Access Compliance Report

Public Rights-of-Way

Intersection ID: 27388	Main Street: CONLAN_CR	Cross Street: BRIXHAM_HILL_AV	Location: SW
ADA ID: B8C76AA0BE2D	Ramp Type: Perp	Initial Pass/Fail: Fail	Overall Compliance: No
		Severity Score: 22.5

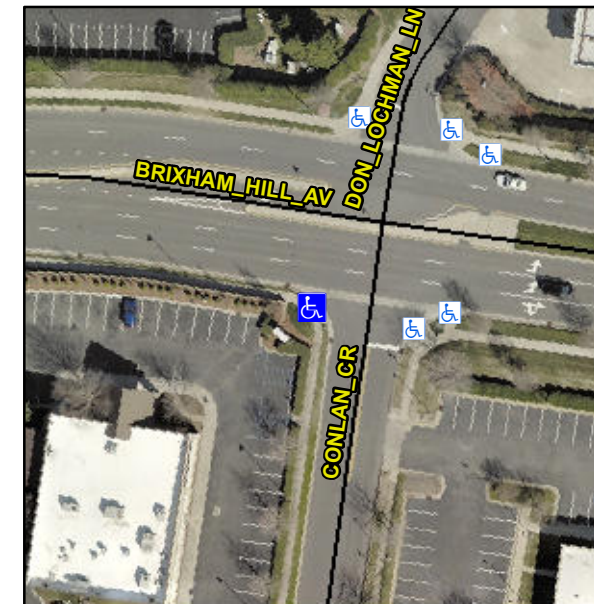
Not Found, R304.5.1, R304.2.2, R304.5.3

Compliance	Description	Data	Compliance	Description	Data
N/A	Ramp Length (in)	81.0	No	Ramp Slope (%)	8.5
No	Ramp Width (in)	47.5	No	Ramp XSlope (%)	3.0
N/A	Flare Type LT	N/A	N/A	Flare Type RT	N/A
N/A	Flare Slope LT (%)	N/A	N/A	Flare Slope RT (%)	N/A
N/A	Flare Traversable LT?	N/A	N/A	Flare Traversable RT?	N/A
N/A	Landing Length (in)	N/A	N/A	DWS Provided?	N/A
N/A	Landing Width (in)	N/A	N/A	DWS Contrast?	N/A
N/A	Landing Slope (%)	N/A	N/A	DWS Length (in)	N/A
N/A	Landing X Slope (%)	N/A	N/A	DWS Full Width?	N/A
N/A	Landing Curb? (Y/N)	N/A	N/A	DWS Offset (in)	N/A
N/A	Shared Landing?	N/A			
N/A	Gutter Ponding?	N/A	N/A	Gutter Slope (%)	N/A
N/A	Gutter Lip Ht (in)	N/A	N/A	Gutter X Slope (%)	N/A
N/A	Painted X Walk1?	No	N/A	Painted X Walk2?	N/A
	X Walk 1 Direction	To SE		X Walk 2 Direction	N/A
N/A	X Walk 1 Width (in)	N/A	N/A	X Walk 2 Width (in)	N/A
	X Walk 1 Slope (%)	2.1		X Walk 2 Slope (%)	N/A
	X Walk 1 X Slope (%)	3.0		X Walk 2 X Slope (%)	N/A

Remove & Replace Entire Ramp.
